Submissions Report

Albion Park Quarry Extraction Area Stage 7 Extension

Application No. SSD 10369

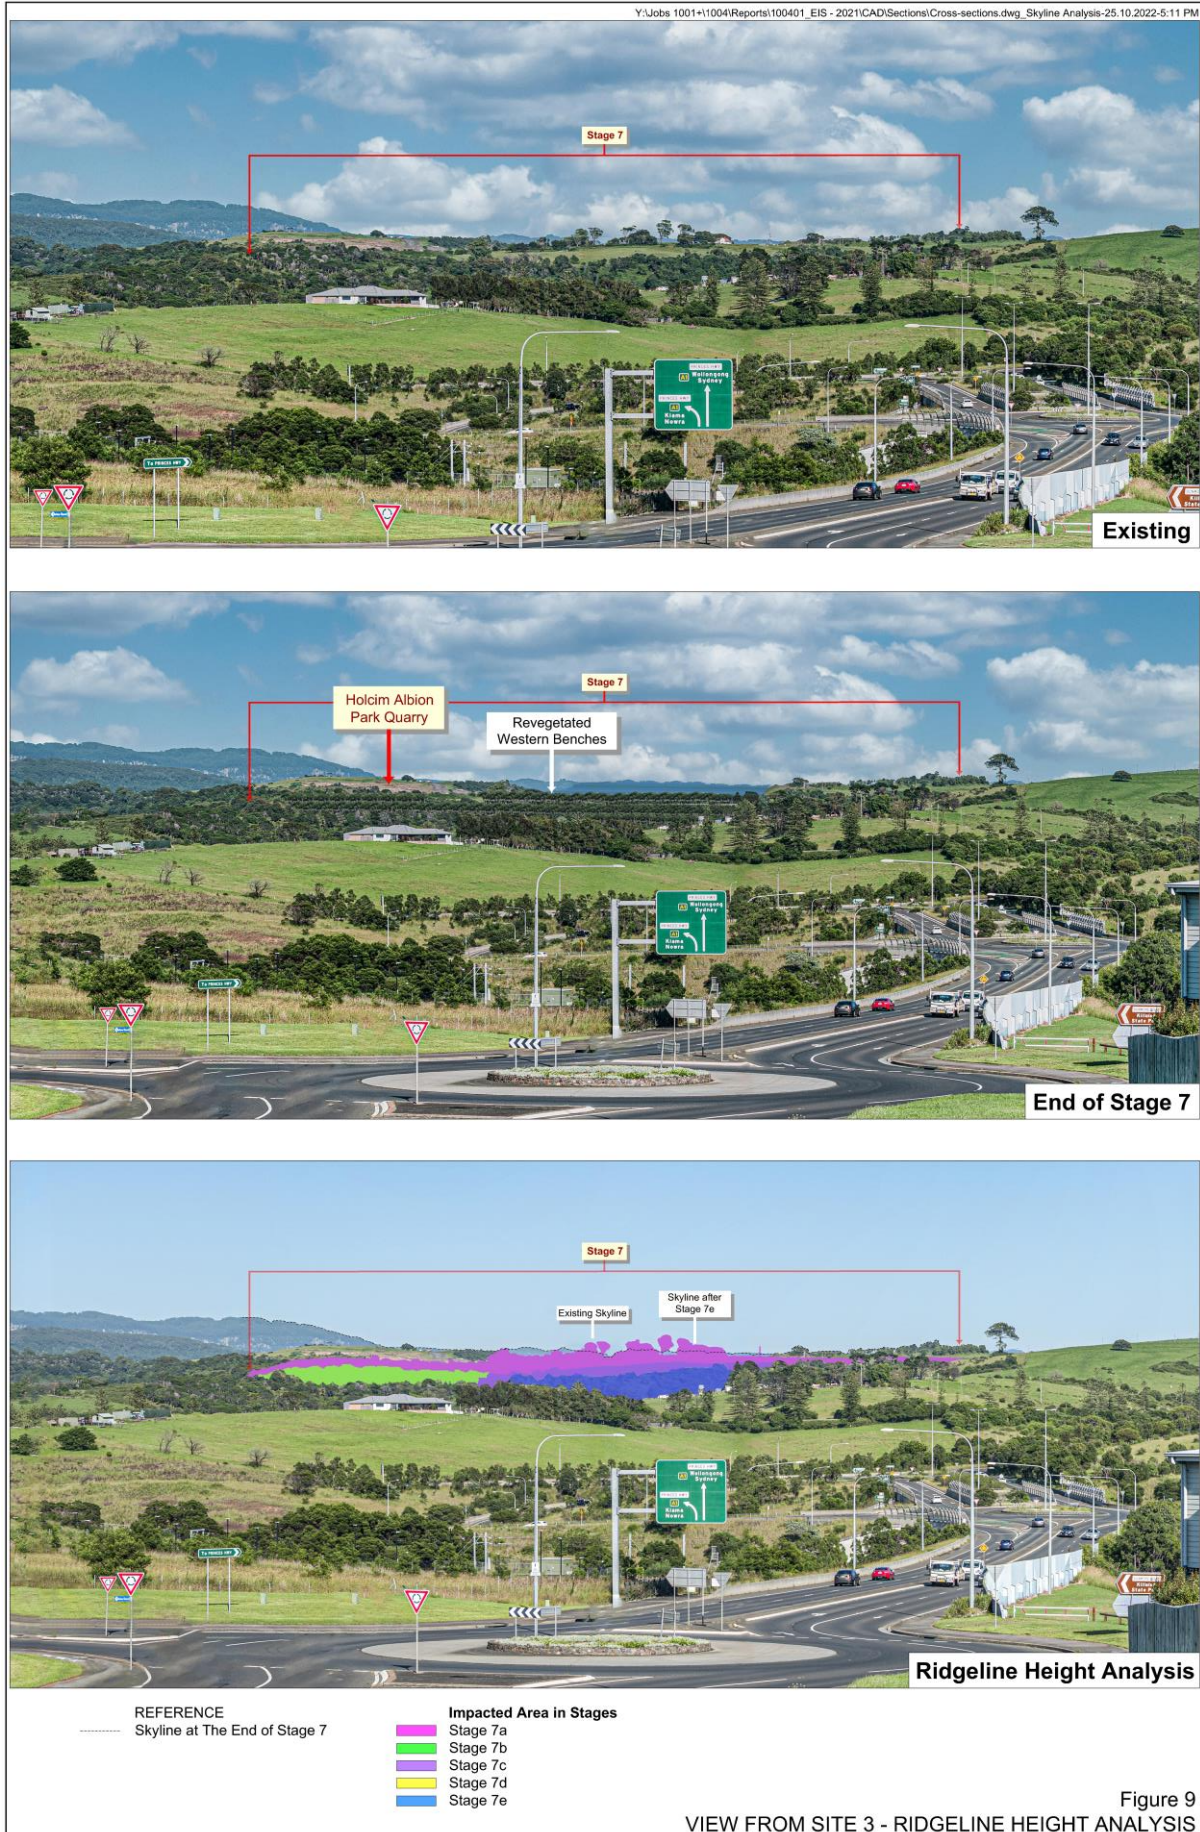
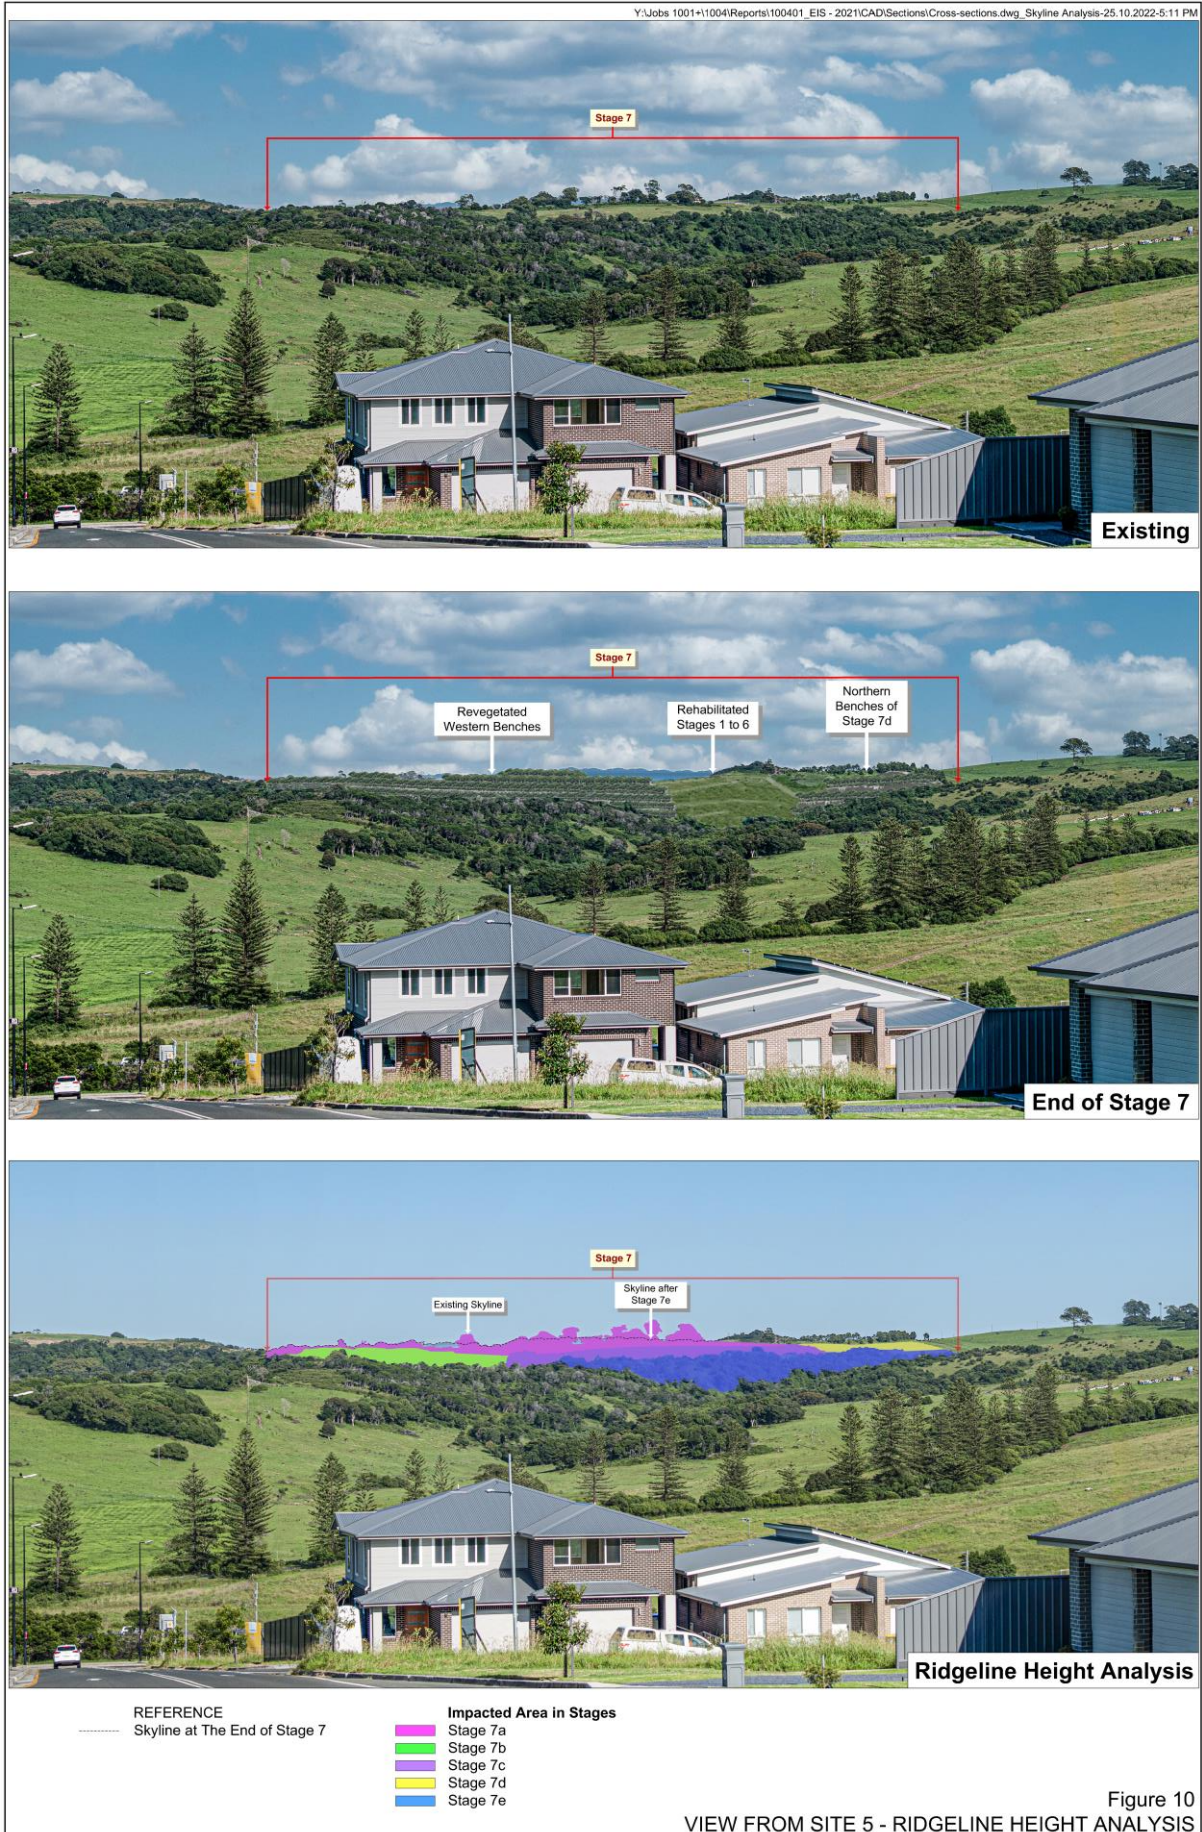
The Visual Impact Assessment does not consider the potential impact of the ridgeline reduction and shape change on the views of surrounding residences.

-
- *Assessment of the permanent visual impact of landform changes and exposed quarry faces. The assessment should consider the impact of the ridgeline height reduction and shape change and the views from receivers with views of the landform change from low lying areas. The assessment should include visual montages and transects.*

Figures 8, 9 and 10 present an analysis of the ridgeline height reduction for Sites 2, 3 and 5 respectively. An analysis of the ridgeline height reduction from the location of the proposed new Shellharbour Hospital is presented in Section 4.2.7.7. The results for Sites 2, 3 and 5 may be summarised as follows.

- Site 2 – the existing skyline from Site 2 in the direction of the amended Project Area is dominated by the Illawarra Escarpment, interrupted by occasional larger trees within the amended Project Area. During Stage 7a, these trees would be removed and there would be a greater area of the escarpment visible from Site 2. There would be no further impacts on the skyline visible from Site 2 throughout the life of the amended Project.

- Site 3 – the existing skyline from Site 3 is dominated to the south of the amended Project Area by the Illawarra Escarpment, with the Holcim Albion Park Quarry visible behind the amended Project Area. In the direction of the amended Project Area, vegetation within the amended Project Area in part obscures the Escarpment. During Stage 7a, the vegetation would be removed, and the Escarpment would become more prominent. There would be no further impacts on the skyline visible from Site 2 throughout the life of the amended Project.

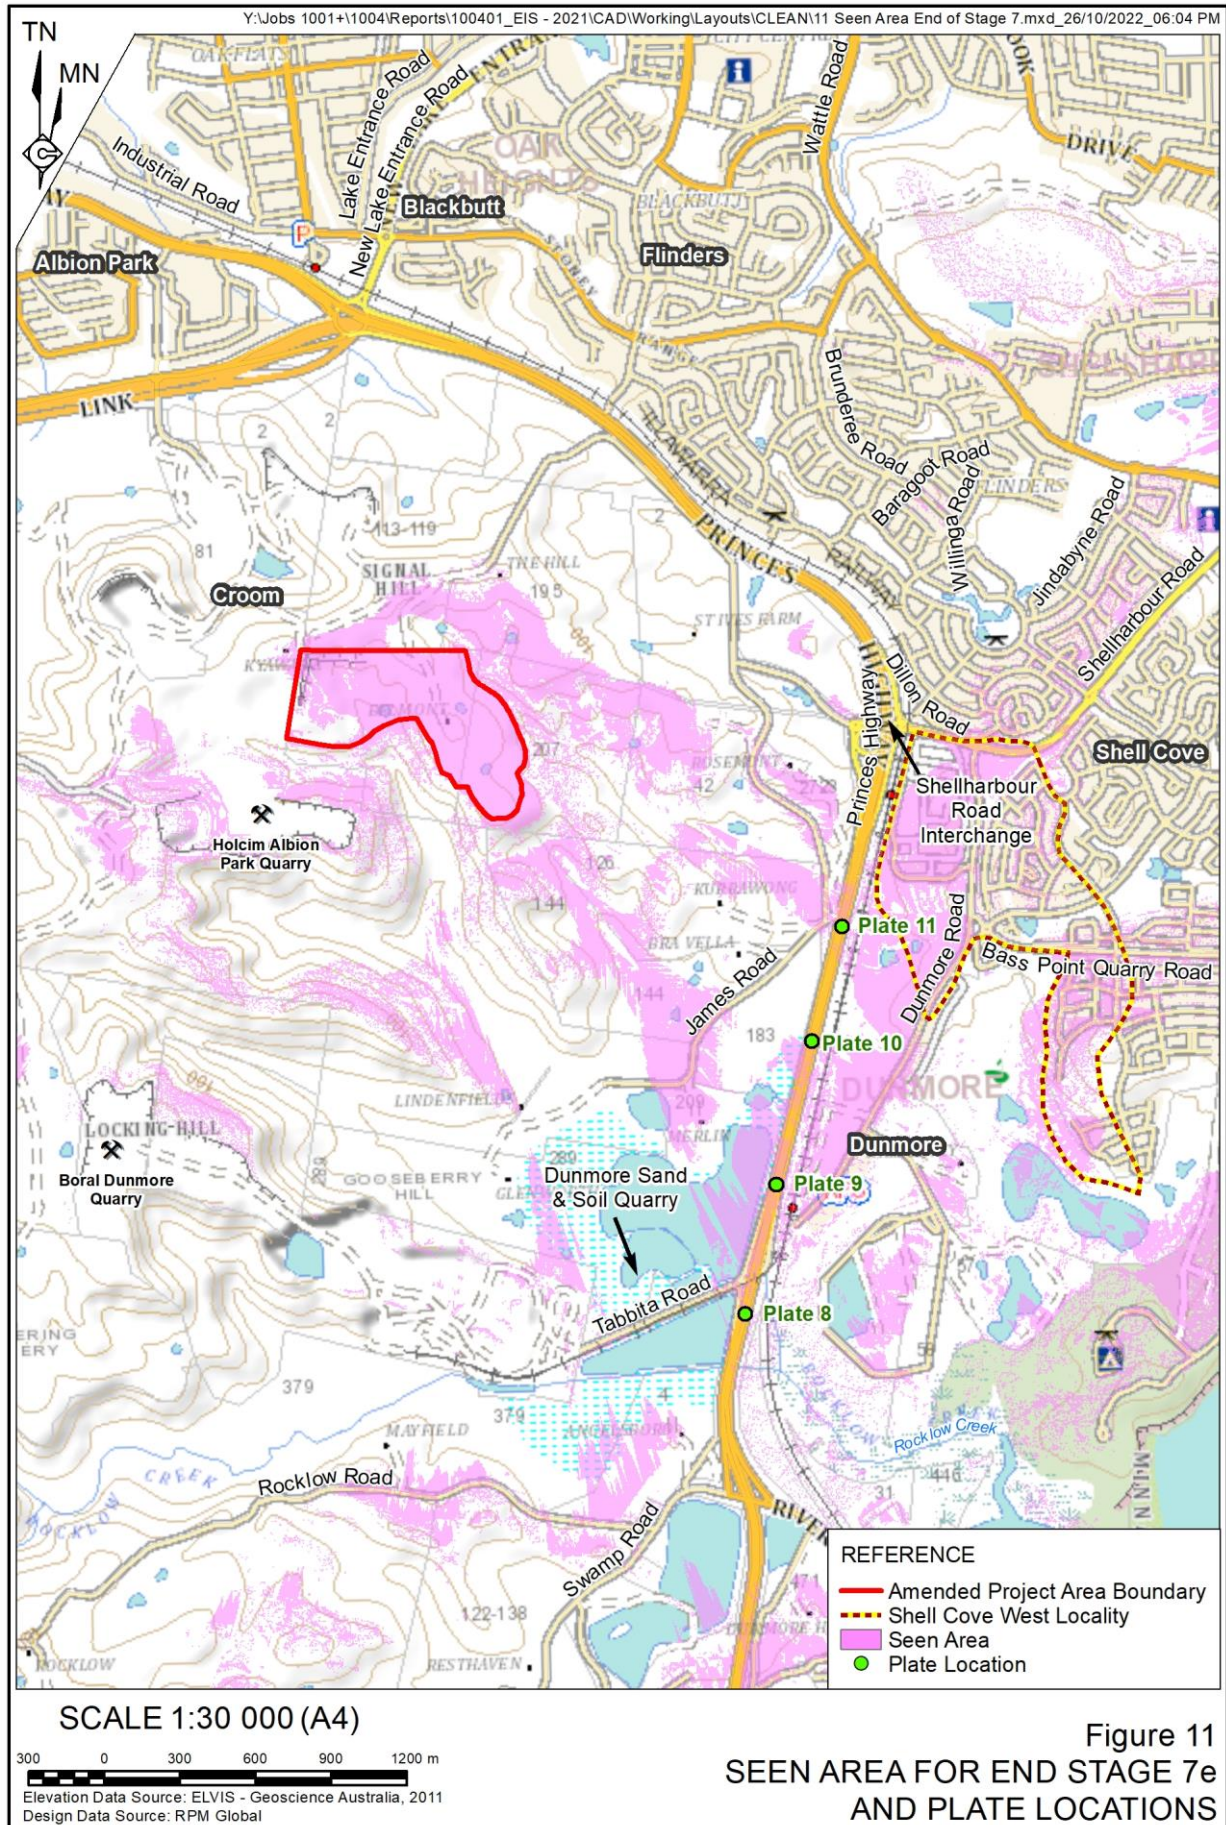
-
- *Detailed assessment of the potential visual impact for road users that quantifies the visual impact of potential landform changes, exposed quarry faces, operational activities, and the final landform on road users travelling on the Princes Highway.*

Figure 11 presents those areas that would, in the absence of intervening vegetation, have views of the final Stage 7e Extraction Area. In summary, the Princes Highway is located relatively low in the topographical setting and for most of the length of the road, the amended Project Area would not be visible.

Plates 8 to 11 present photographs taken from a vehicle travelling northwards along the Princes Highway to the east of the amended Project Area. Approximate photograph locations are presented in **Figure 11**.

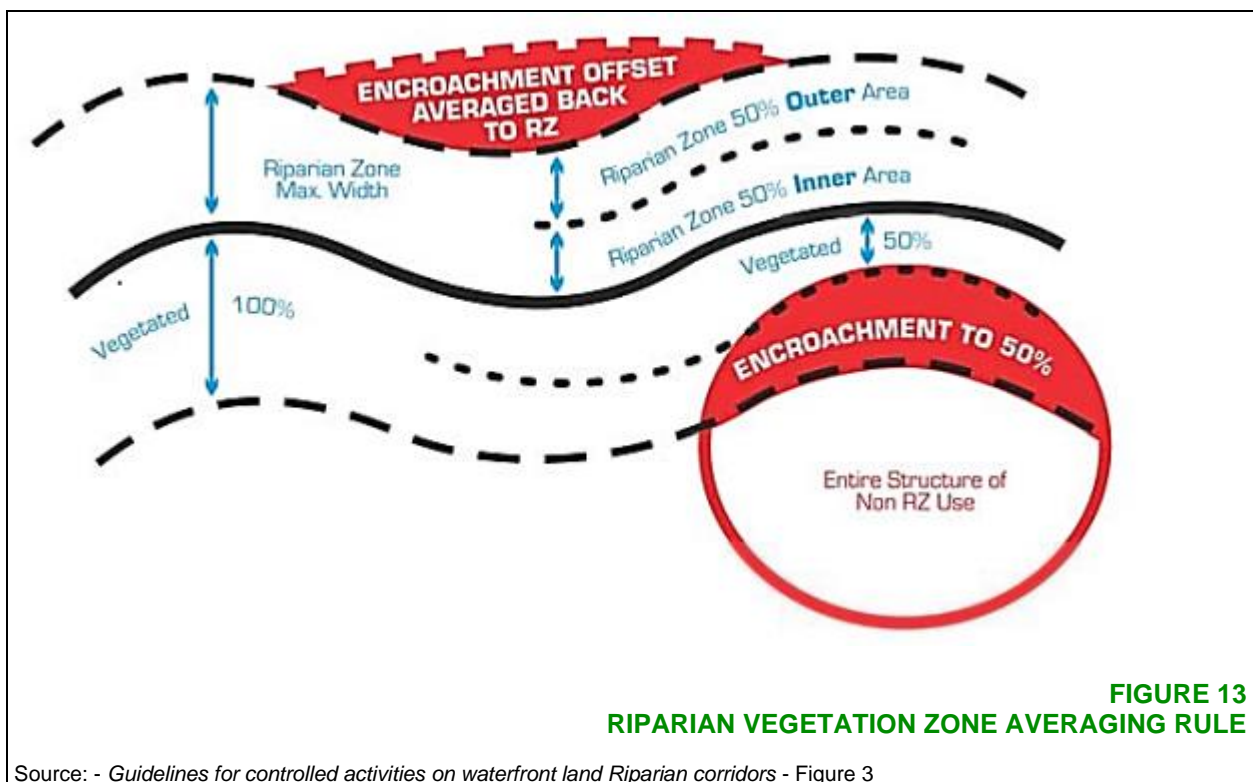
A review is requested of the works on waterfront land to show due consideration to the setback requirements in the Guidelines for Controlled Activities on Waterfront Land.

The *Guidelines for Controlled Activities on Waterfront Land* describe a minimum Riparian Vegetation Zone (RVZ) from the top of bank of the watercourse of 10m from a 1st Order watercourse and 20m from a 2nd Order watercourse. This RVZ consists of an inner zone comprising 50% of the RVZ which must be maintained as a vegetated buffer, and the remaining outer zone which can include some development subject to the “averaging rule”. The averaging rule allows for encroachment into the outer zone provided an equivalent offset area is added to the RVZ elsewhere within the development site, as shown in **Figure 13**.

The Project will encroach into the outer zone along the length of Watercourse 6 that adjoins the amended Extraction Area. Utilising the averaging rule, an equivalent area would be offset along the eastern bank of the watercourse to maintain the total area of the RVZ on the property. Prior to the commencement of any ground disturbance activities in the Stage 7e area (which is the area adjoining Watercourse 6), the top bank of the watercourse will be identified by ground survey, and the distance equivalent to the inner riparian zone (5m for the section of 1st order watercourse and 10m for the section of 2nd order watercourse) would be permanently marked, and would form the disturbance limit in this area of the amended Project. This will ensure no intrusion into the inner riparian zone.
